## SGRE Response to GC0137 Consultation on Minimum Specification Required for Provision of GB Grid Forming (GBGF) Capability.

**Project name:** National Grid GC0137

This document makes specific comments on “Workgroup Consultation: GC0137: Minimum Specification Required for Provision of GB Grid Forming (GBGF) Capability” [1] and the Grid Forming Converter Specification 30 March 2021 [2].

Simplified linearised VSM control – Angle driven  
Showing typical additional paths for drivetrain damping

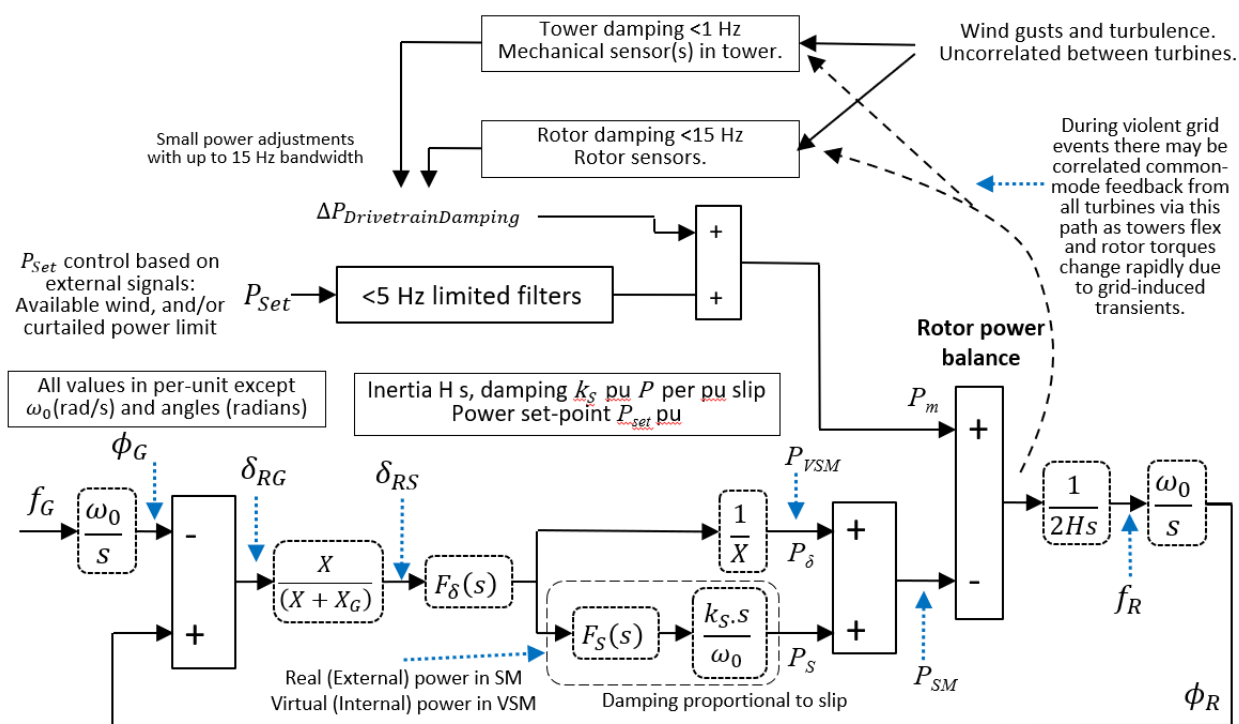
Importantly, there are other control functions which do not fit neatly into “inner VSM” or “outer control based”, and fall between the two “definitions”.

As a specific example, within wind turbines, there are some internal damping mechanisms with bandwidths which extend to 10-15 Hz that can be active at low per-unit power levels, when tower or blade oscillations are detected, that need to be damped. There are no external control or electrical grid inputs to these functions. The algorithms do not directly measure grid-side frequency, voltage, or phase angle. The inputs from sensors and rotor speed are part of the internal closed-loop turbine control at each turbine, and normally the small power fluctuations created at each wind turbine are uncorrelated with each other, and also buried beneath the natural power fluctuations that occur due to fluctuating wind speed at each turbine. The only time the drivetrain damping power fluctuations might be evident to an outside observer would be after a significant grid event/fault that caused all turbine towers/rotors to flex, in a common-mode fashion across a whole park, resulting in required damping actions at all turbines in a coordinated fashion. This scenario might (if the event is large enough) fall under the “Exceptions to the rule” defined in “Grid Forming Capability”, where bandwidth excursions are allowed during transients caused by system faults.

All large wind turbines probably include such drivetrain damping control loops with up to ~15 Hz bandwidth and, to date, no concern has been made about their impact on the network. Normally the drivetrain damping actions are uncorrelated across the turbines in a park/region, being due to wind gusts/fluctuations which vary at each turbine. Removal of these functions from the turbine would not be viable as the result would be dramatic shortening of turbine lifetimes, and/or mechanical failures during operation.

To illustrate the point, Figure 1 shows a much simplified and “generic” VSM algorithm, taken from [3], and augmented with a typical drivetrain damping loop. The main power setpoint input, due to user constraints or available wind assessment at each turbine, can relatively easily be constrained to a 5 Hz bandwidth. However the drivetrain damping components for the rotor cannot be constrained to a 5 Hz bandwidth and could extend to 15 Hz. This drivetrain damping loop has to be present to avoid turbine damage/destruction, and does not include any external inputs which the user can control or influence. Normally the dominant path is from fluctuating/gusting/turbulent wind at each turbine, which produces small power fluctuations that sometimes require to be damped to avoid certain mechanical resonant modes from becoming excited. These power fluctuations will not be correlated between turbines. There is also another path, which can become active if a large grid fault or transient excites common-mode tower flexing and/or mechanical torques across all turbines in a farm. In this case, there will be some correlated damping power across all turbines exposed to the grid transient. The power involved in these damping actions is limited to a small
